3 Presentation of officer reports

3.1 336 & 338 Riversdale Road and 2 Clive Road, Hawthorn East - Four storey apartment building - PP23/0472

Executive Summary

PLANNING ASSESSMENT

Above: Apartment 204 balcony encroachment into Standard B17 setback (clouded)

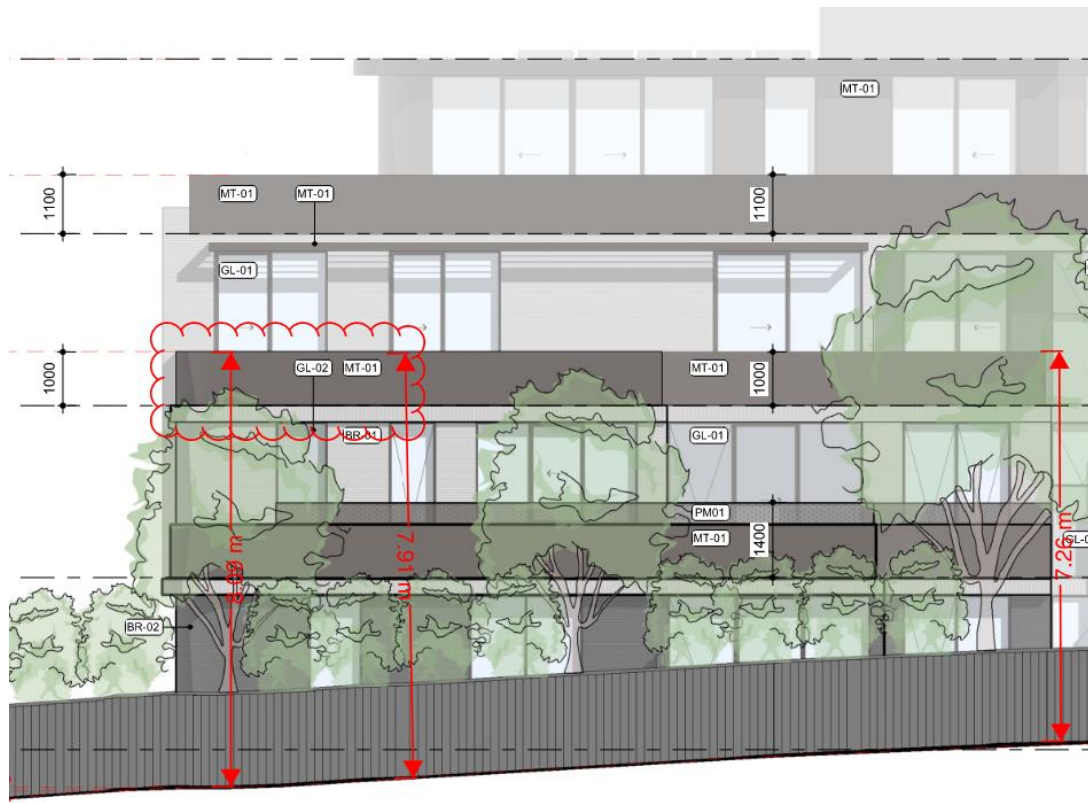
The balcony associated with Apartment 204 encroaches into the Standard by up to 180mm adjacent to Bedrooms 2 and 3. In this location, the balcony has a height ranging from 7.9m to 8.09m from Natural Ground Level which requires a setback of 3m to 3.18m respectively. A setback of 3m in this area is proposed. The area of encroachment is depicted (clouded) below.

Above: Apartment 302 & 303 balcony encroachments into Standard B17 setback (clouded)

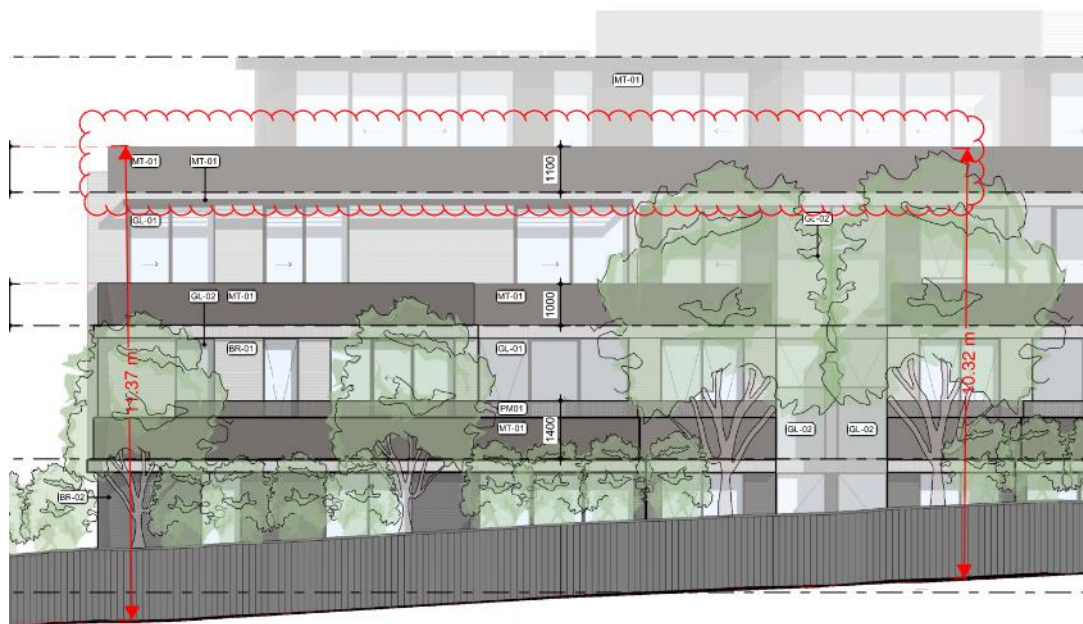
The balconies associated with Apartments 302 and 303 encroach into the Standard by up to 1.06m adjacent to Apartment 302's master bedroom and living/dining, and Apartment 303's living/dining and kitchen. In this location, the balcony has a height ranging from 10.32m to 11.37m from Natural Ground Level which requires a setback of 5.4m to 6.46m respectively. A setback of 5.4m in this area is proposed. The area of encroachment is depicted (clouded) below.

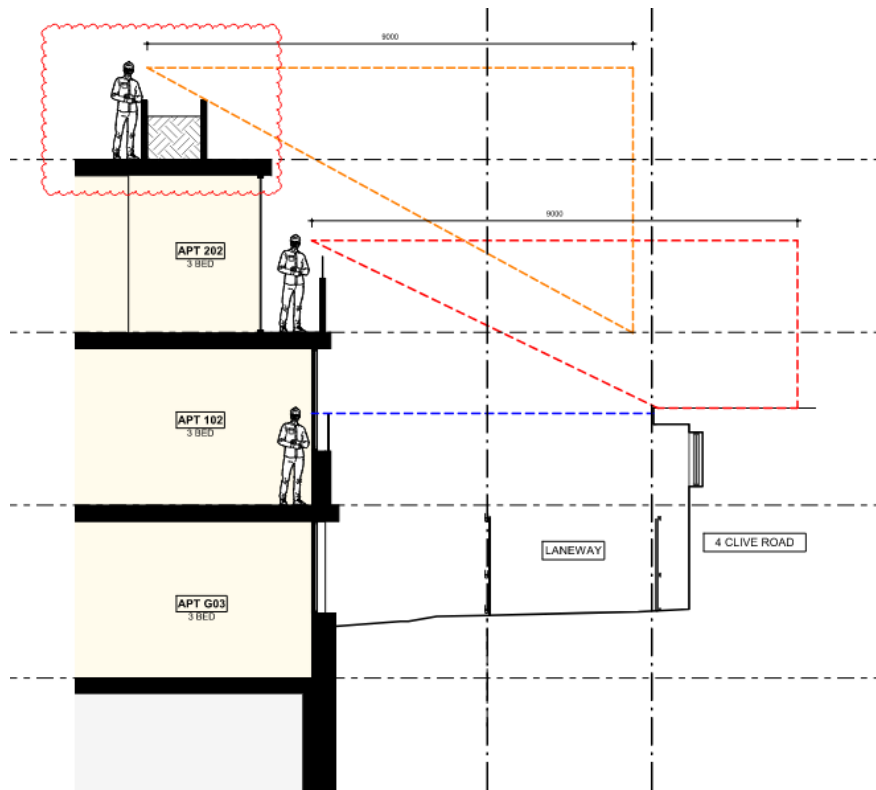
- The south-facing balcony of Apartment 202 and habitable room windows of Apartment 201 on Level 2 to be screened to comply with Standard B22 (Overlooking).
- Height of balustrade and width of planter boxes on the balcony of Apartment 301 on Level 3 dimensioned from Finished Floor Level on the South Elevation or demonstration compliance with Standard B22 (Overlooking) has been achieved.
- The south-facing balconies of Apartments 101 and 201 screened to comply with Standard B22 (Overlooking).

Tree 28 - is proposed to be retained.

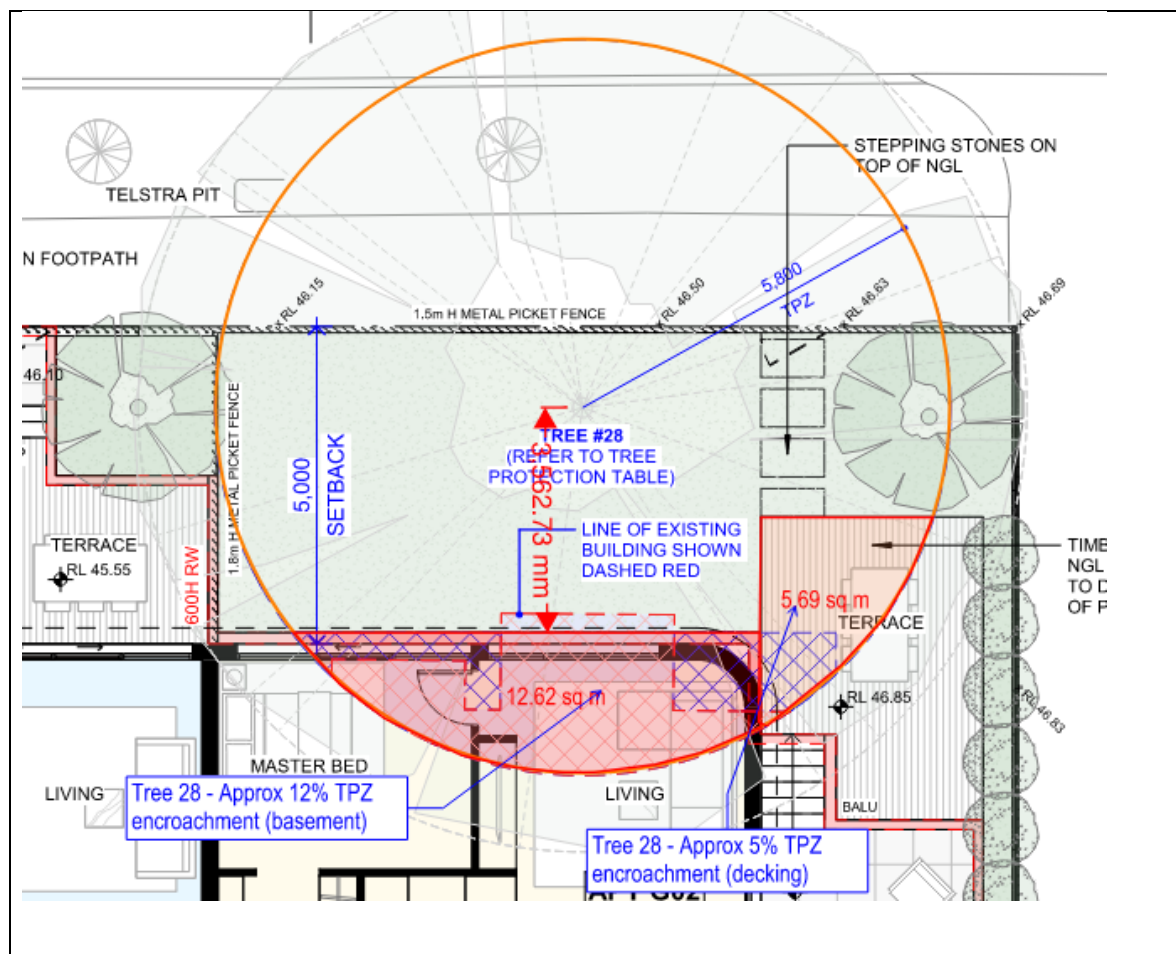
- The non-destructive root investigation identified several roots from the tree that would be impacted by the proposed development.
- John Patrick Landscape Architects have assessed that the tree will not be detrimentally impacted by the proposed works, and this conclusion was supported by council as part of PP22/0151.
- The proposed basement represents a TPZ encroachment of approx. 12%, much of which was existing within the original building footprint. The proposed decking represents a further TPZ encroachment of approx. 5%. This level of encroachment is less than that previously supported and is considered a good outcome.
- Previous advice provided as part of PP22/0151 supported construction of the basement and above floors as long as there was a minimum 3m clearance. The current proposal allows approx. 3.5m setback which would again be supported.

Level 3

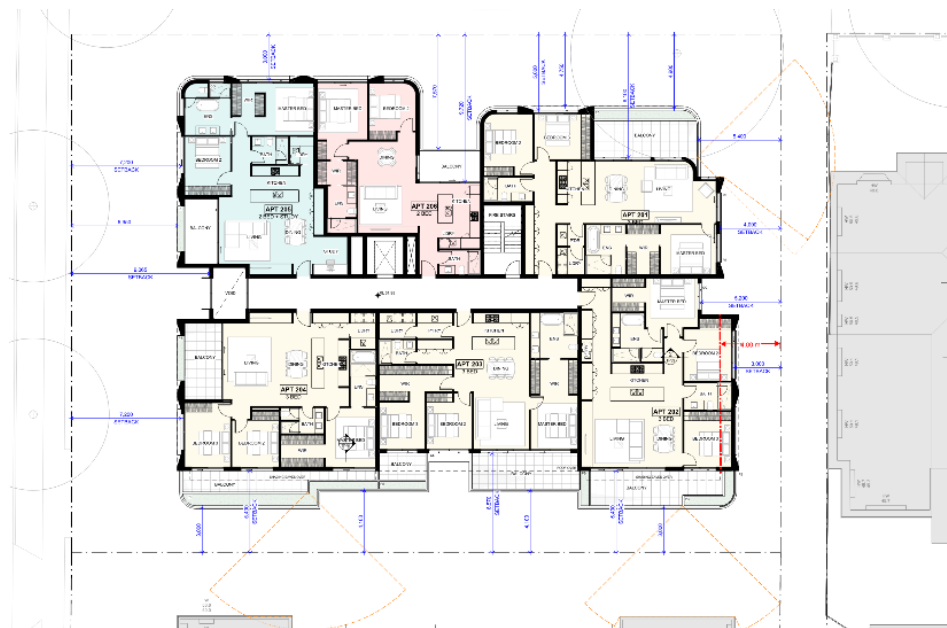
6. However, reading between the lines, it is clear that the member considers the visual impact on the adjacent southern neighbour and its limited open space to the rear as unfavourable. While this is partly attributed to the upward slope of the land to the south, the onus is on the applicant to ensure their development has minimal off-site impacts. In that regard, the southwest corner seems to be equally problematic, causing unwarranted overshadowing and visual bulk concerns for the adjoining southern property. An ideal outcome would see the mass erosion happening on the

two upper levels of this corner too, albeit to a lesser extent than the east. We have marked up some indicative setbacks in red on the extracts of Levels 3 & 4 below, which should facilitate this outcome.
